1 **Comment (#85, #100, #101, #125, #127, #132, #133, #134, #136, #137)**

3 Single signature state machines

13 Dual-single signature state machines

Figure 145-26—Type 3 and Type 4 single-signature PD state diagram

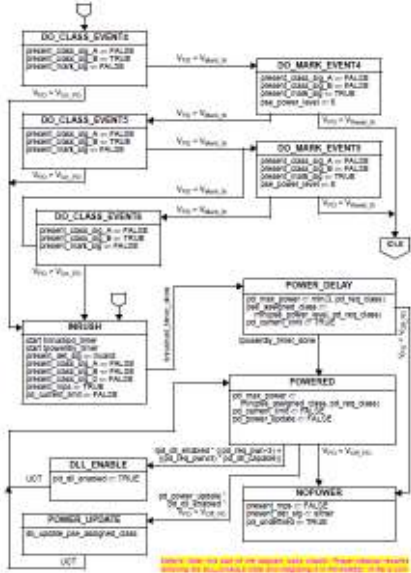
-Editor to remove “BEGIN” from the relevant states per yseboodt_07_0317.pdf proposal

- To add to TODO list: We want that before the PD is going to IDLE and its *pd_dll_enabled* became FALSE, to fill the TLV field value with 0. (To consider to add new state that when before the PD is entering to IDLE it

Figure 145-27—Type 3 and Type 4 single-signature PD state diagram (Continued)

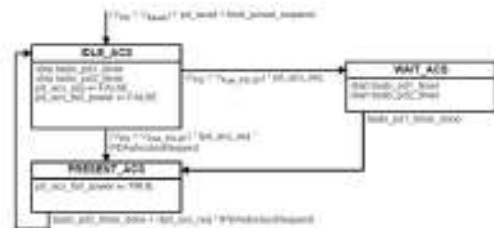
-Editor to replace *pd_req_pwr* variable (it is PSE and not PD variable) with *pd_req_class* in Figure 145-27 in all locations.
